Response to Submission and Additional Information - *Department of Planning, Housing and Infrastructure* Crows Nest Overstation Development - Site B

Additional Information Request		Response:
<p>1.A</p>	<p>Review and revise the façade treatments of the car parking levels to provide an appropriate horizontal height datum/ delineation between the station and the development (as recommended by the Design Guidelines) and to reduce its visual impacts. This may include consideration of:</p> <ul style="list-style-type: none"> i. Additional landscaping along the car parking level and provide details to demonstrate any landscaping would be practical and viable ii. Sections to indicate how the proposed new columns that are to be extended up to the transfer slab, and the car park façade screen are integrated. iii. The extent/ height of the terracotta façade and how that relates to the desired streetscape. 	<p>The façade expression at the car park level, above the metro station, is dictated by the location of structure that extends from the station. In some locations, this structure sits directly along the façade line, meaning that creating a recessive element at the car park levels poses a ch

03.02 Amenity Solar Access

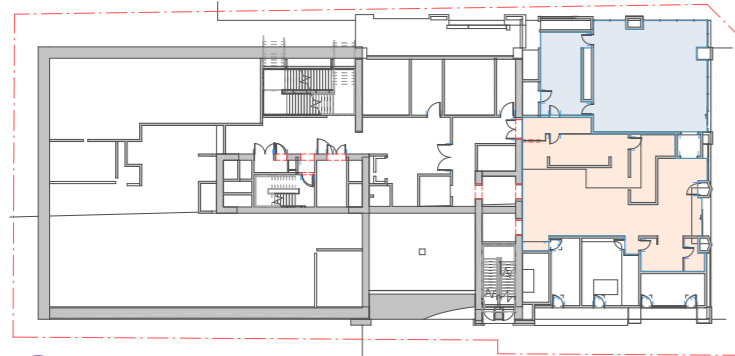
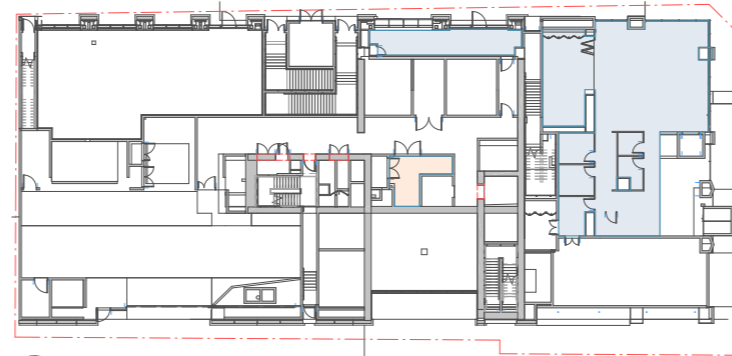
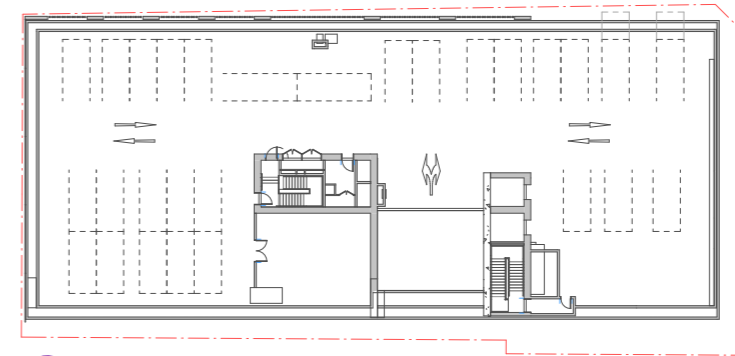
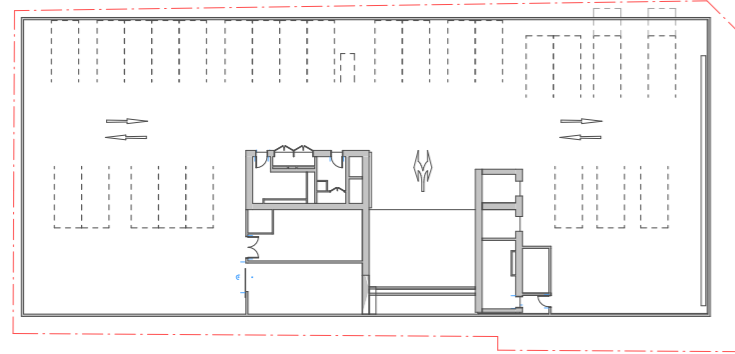
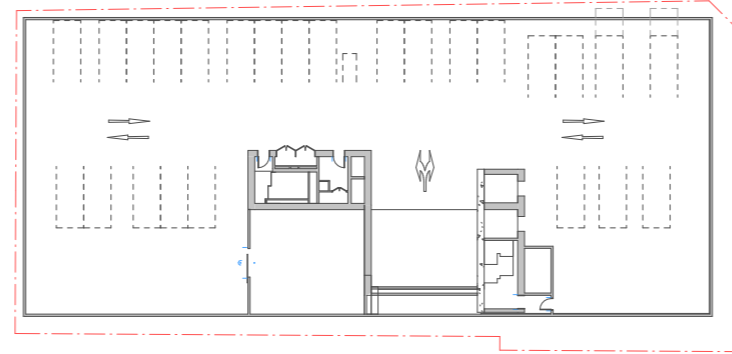
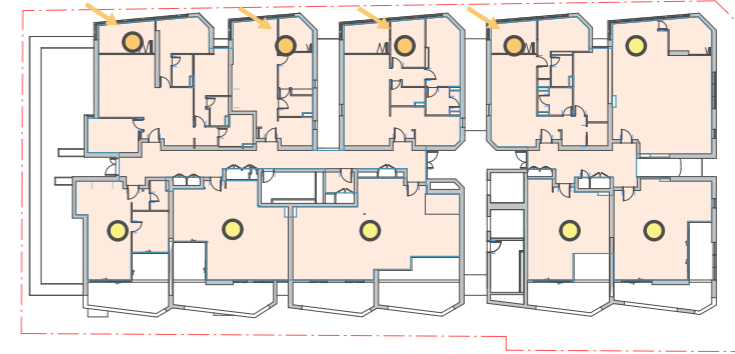
Additional Information Request		Response:
2.A	<p>Provide further details, including supporting documentation and drawings to illustrate how the proposal will meet the objectives and criteria of the Apartment Design Guide (ADG). This must include:</p> <p>a) How the proposal maximises solar access, including identifying:</p> <ol style="list-style-type: none"> the number of apartments that receive two or more hours of solar access the extent of solar access received by those apartments that receive less than two hours of solar access; and the extent of apartments that receive no direct solar access. 	<p>Drawings DA-2303, DA-7721, DA07722 address solar access to units. 62% (76 units) achieve more than 2 hours of direct sunlight between 9am and 3pm at mid-winter. 38% (46 units) achieve 1 hour 45 minutes of solar access between 3:15 -5pm at mid-winter. Achieving the ADG design guidance for solar access is not possible on this site due to the long east and west orientation. The proposed development improves amenity for those apartments with less direct sun access in the following ways:</p> <ol style="list-style-type: none"> Significant views are oriented away from the desired aspect for direct sunlight along the western Pacific Highway façade. The proposal orients the west facing units to the south where there are views back to the harbor and city. Where apartments receive no direct solar access from 9am - 3pm during mid-winter, greater separation between units is proposed to increase access to daylight throughout the year. <p>Refer to Appendix 3.02</p>

62% (76 units) Meet 2 Hour Requirement
 38% (46 units) Feature Additional Natural Light at Building Openings
100% Total

*Achieving the design criteria may not be possible on some sites. This includes:
 - where greater residential amenity can be achieved along busy road or rail line by orientating the living rooms away from the noise source
 - on south facing sloping sites
 - where significant views are orientated away from the desired aspect for direct sunlight"
